GA No. : 告示编号:	GA-18-001	Issued Date 发出日期:	2018-03-20
		Issued By 发行人:	刘聪聪
Classification : 类别	Change length of taping leader & trailer 更改装料带首尾空带长度	Approved By 批准人:	部门经理 – 张海萍 运作经理 – 王小林 QA 经理 – 陈水枪 市场业务部经理 – 黄良惯 总经理 – CS Chan

**TITLE:** Change on taping Leader and Trailer length for all SOD/SOT devices

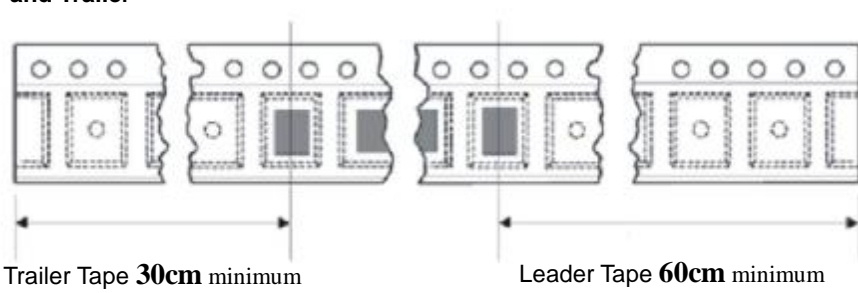
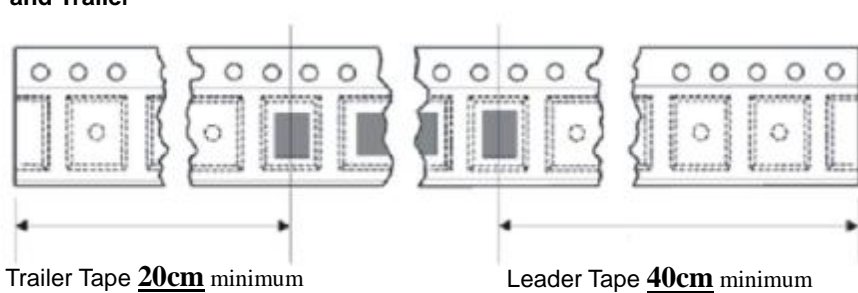
To optimize the manufacturing capacity & improve the production efficiency, Tak Cheong is notifying the change on the length of taping Leader & Trailer for all SOD & SOT devices in 7 inch reel. Details as below table:

<b>From:</b>	<p><b>Taping Leader and Trailer</b></p>  <p style="text-align: center;">Trailer Tape <b>30cm</b> minimum      Leader Tape <b>60cm</b> minimum</p>
<b>To:</b>	<p><b>Taping Leader and Trailer</b></p>  <p style="text-align: center;">Trailer Tape <b>20cm</b> minimum      Leader Tape <b>40cm</b> minimum</p>

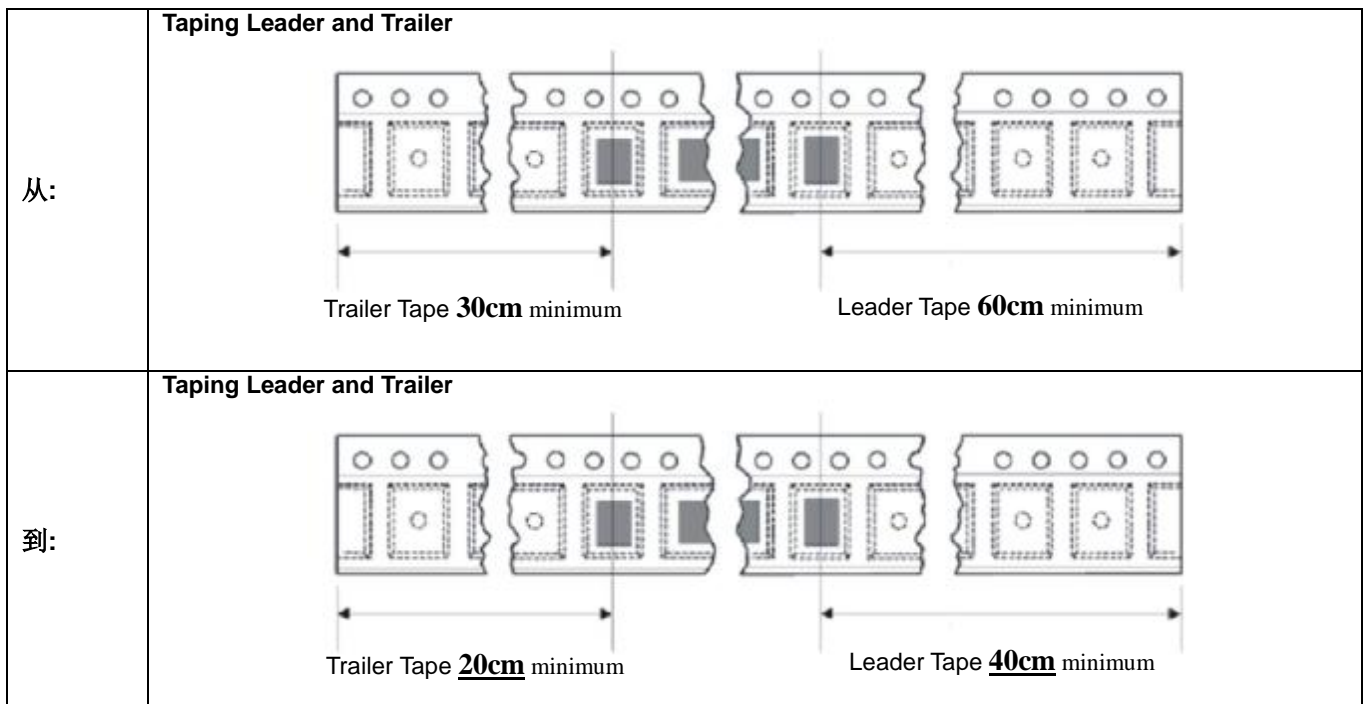
为优化制造生产能力, 提高生产效率, 德昌将更改SOD/SOT产品 (7 inch卷板) 装料带的首尾空带长度. 具体如下:
